Access Compliance Report Public Rights-of-Way (Curb Ramps)

Main Street: FAIRLYNN_BLV D Cross Street: OAKVALE_DR Location: NE

ADA ID: RPAT210923101938 Ramp Type: Type 4 - Parallel Initial Pass/Fail: Fail Overall Compliance: No Severity Score: 15

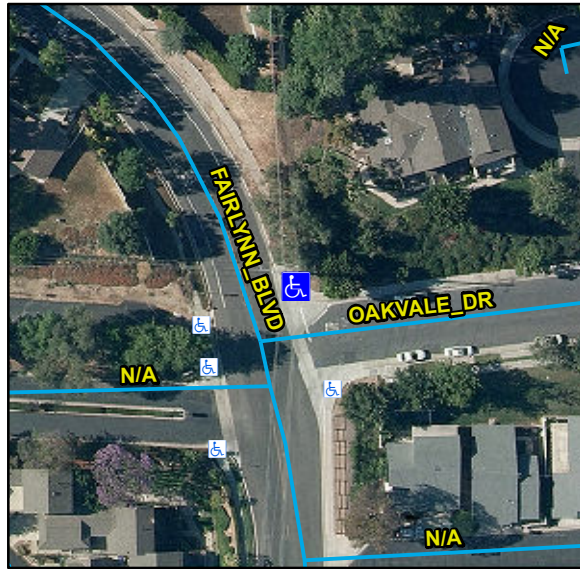
Compliance	Description	Data	Compliance	Description	Data
N/A	Ramp Length LT (in)	124	N/A	Ramp Length RT (in)	124
Yes	Ramp Width LT (in)	85	Yes	Ramp Width RT (in)	73
No	Ramp Run Slope LT (%)	8.7	Yes	Ramp Run Slope RT (%)	6.6
Yes	Ramp Cross Slope LT (%)	0.6	Yes	Ramp Cross Slope RT (%)	1.3
N/A	Landing Present	N/A	N/A	DWS Provided	N/A
N/A	Landing Length (in)	N/A	N/A	DWS Contrast	N/A
N/A	Landing Width (in)	N/A	N/A	DWS Length (in)	N/A
N/A	Landing Run Slope (%)	N/A	N/A	DWS Full Width	N/A
N/A	Landing Cross Slope (%)	N/A		DWS Offset Type	N/A
N/A	Landing Movement Obstructed?	N/A	N/A	DWS Offset Left (in)	N/A
	Landing Movement Type	N/A	N/A	DWS Offset Right (in)	N/A
N/A	Landing Shared	N/A			
N/A	Clear Space	Yes			
N/A	Clear Space To Crosswalk (in)	N/A			
N/A	Marked Crosswalk 1	No	N/A	Marked Crosswalk 2	No
	Crossing 1 Direction	W		Crossing 2 Direction	S
	Marked Crosswalk 1 Width (in)	N/A		Marked Crosswalk 2 Width (in)	N/A

Remove & Replace Curb Ramp With Two New Directional Ramps or Equivalent.
